From: Scala, Mary Joy
Sent: Thursday, September 18, 2014 1:41 PM
To: 'Robert Nichols'
Cc: cwispelwey@nbwla.com
Subject: BAR Action - September 16, 2014 - 310 E Market Street

RE: Certificate of Appropriateness Application

BAR 14-09-07
310 East Market Street
Tax Parcel 330220000
Aaron Burr, Owner/ Robert Nichols, Formwork Architecture LLC, Applicant
Comprehensive interior rehab; demolish 1-story additions; paint brick; create new courtyard entry

**CITY OF CHARLOTTESVILLE
BOARD OF ARCHITECTURAL REVIEW
STAFF REPORT
September 16, 2014**

2 PARTY WALL ELEVATION

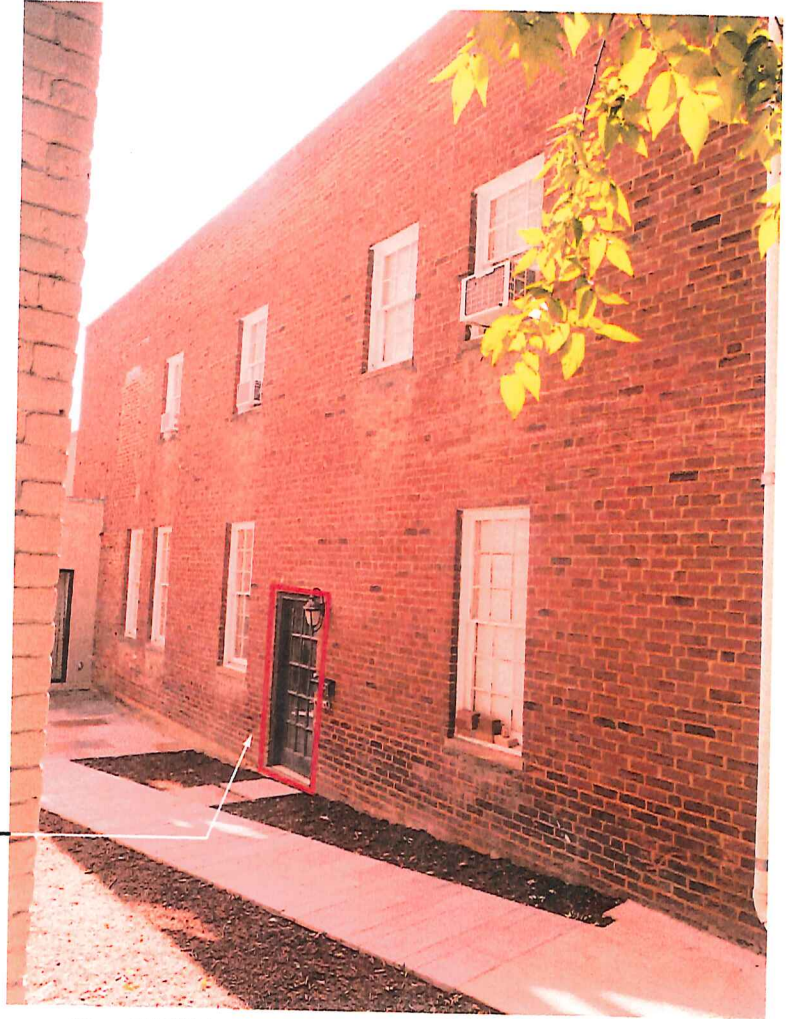
For purposes of an application to BAR for approval of a design and materials for closing and bricking up the doorway on Aaron Burr's one half side of the wall, I do not think that Mr. Kabbash's signature is necessary.

The proposed work cannot extend into Mr. Kabbash's one half side of wall without his agreement or court order ordering him to close the doorway on his half side wall.

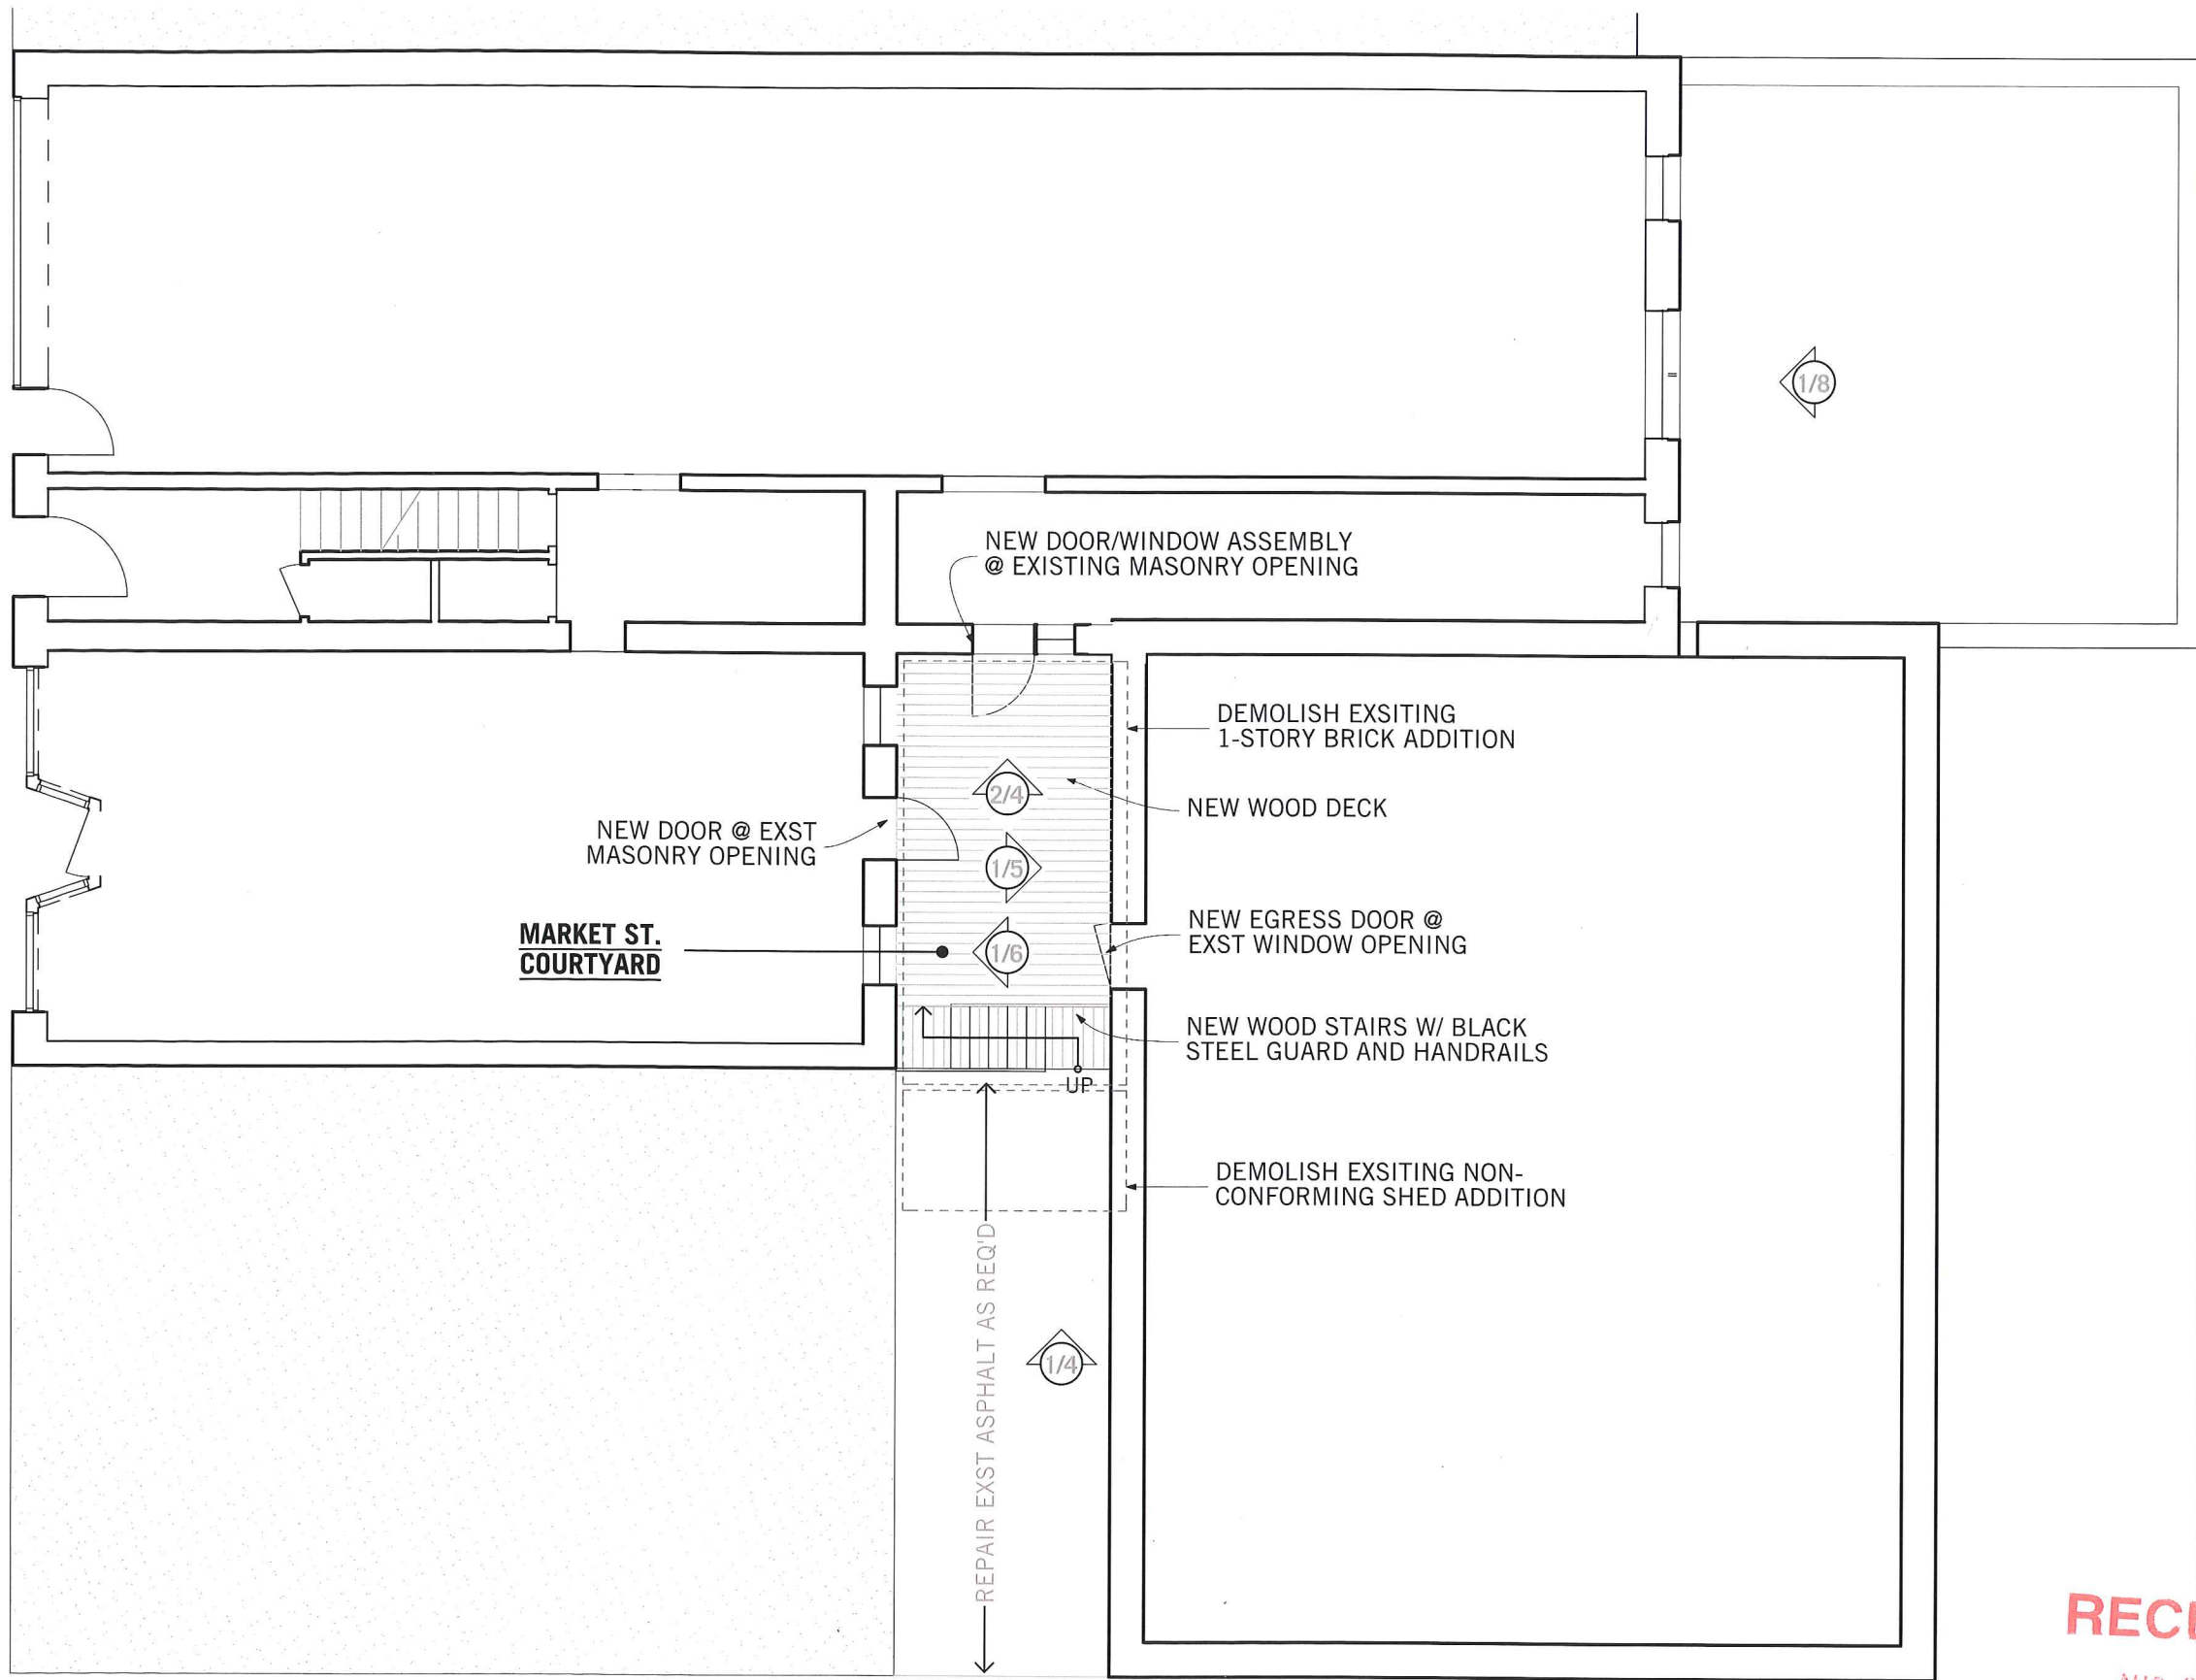
The BAR may wish to comment on the plan to replace the existing windows with doors on both the east and west side of the alleyway and how that will affect the rhythm and pattern of voids in the structure. However, it is very difficult to see the elevations directly, and this area has been encapsulated for years.

The BAR approved (8-0) the application as submitted.

1 REAR ELEVATION - PROPOSED

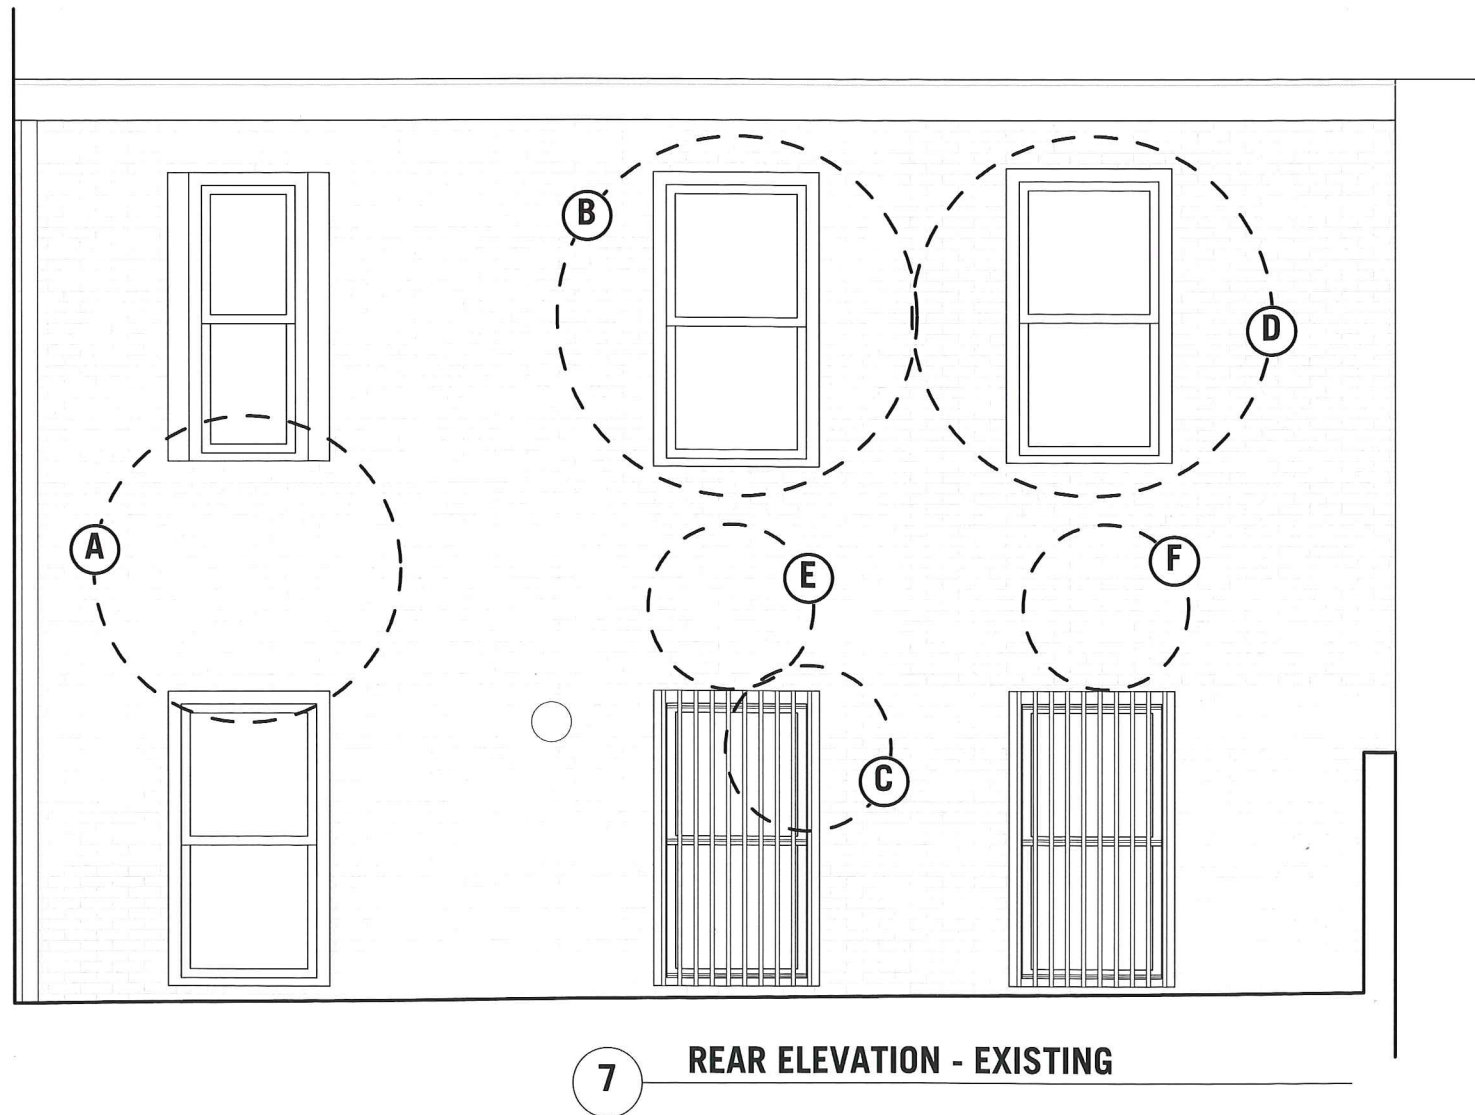
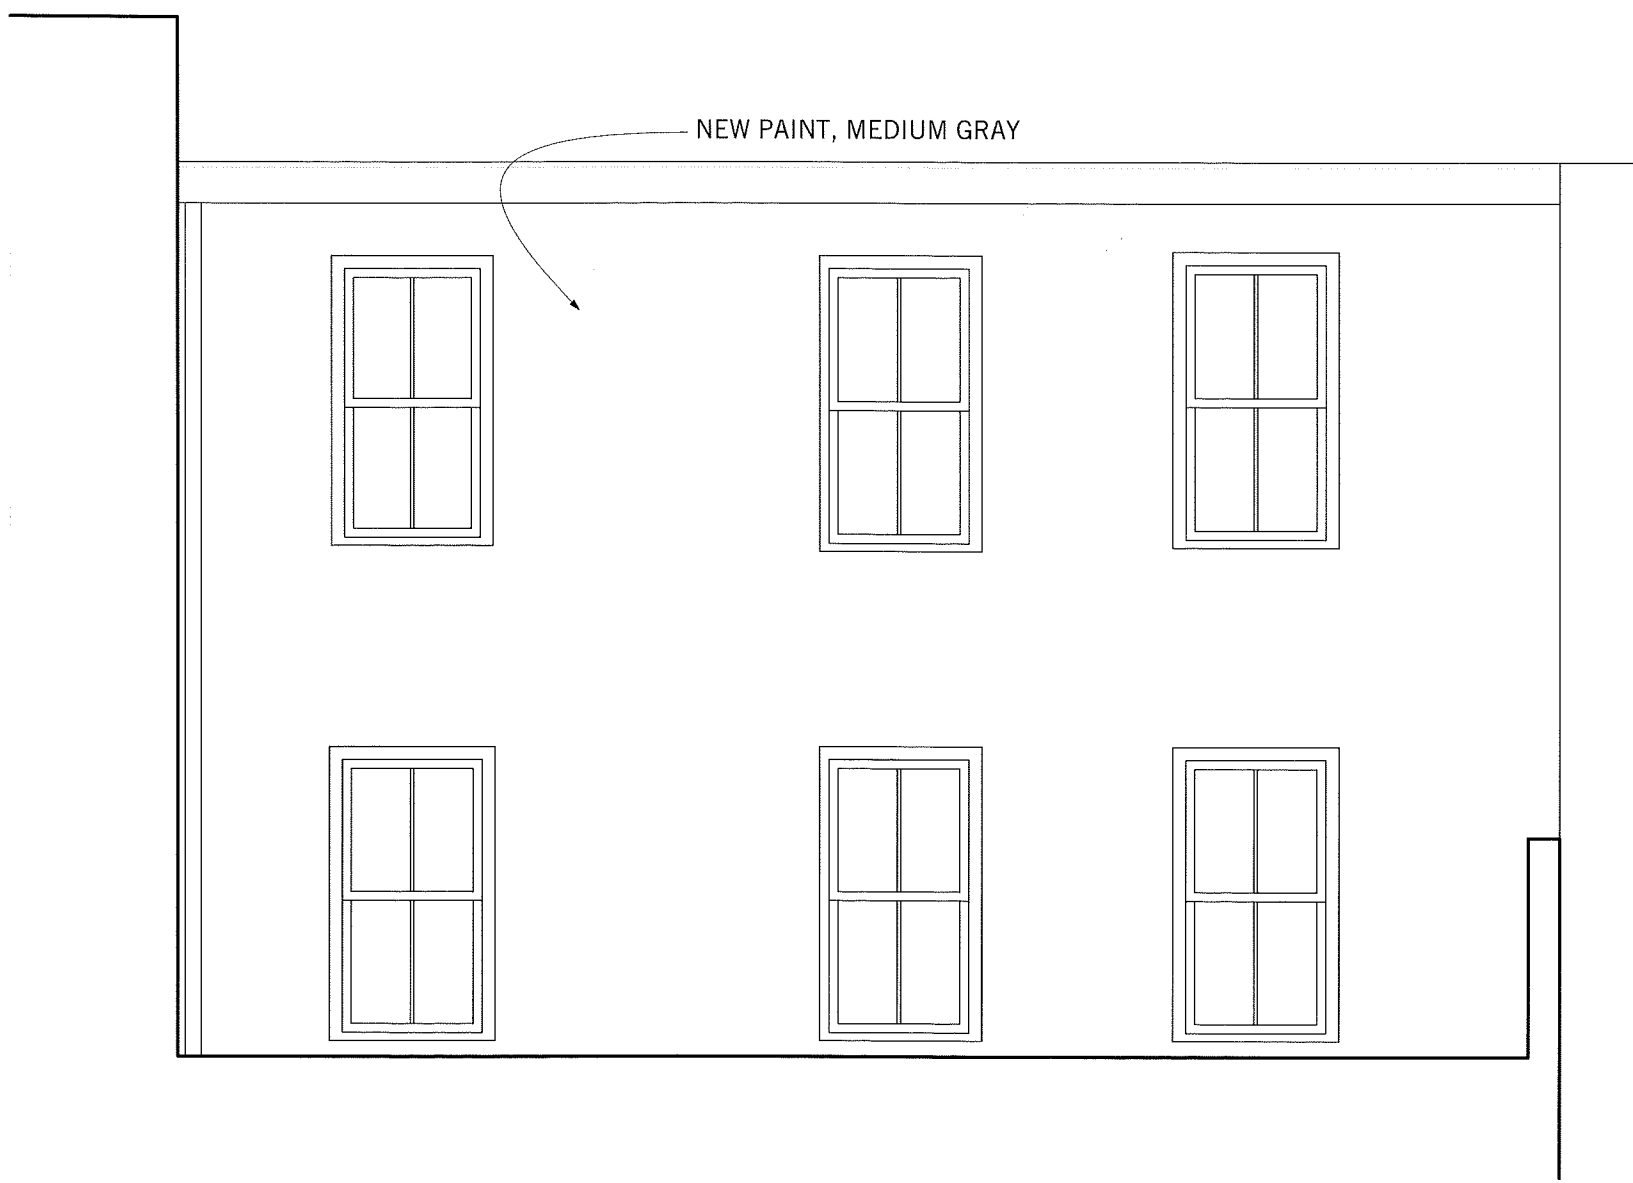
The area of unpainted brick to be painted is only visible from adjacent buildings.

Also, the exterior changes being approved should be specified (the color of paint for the brick, the type and color of wood being used for the deck, etc.) The type of replacement windows should be specified.
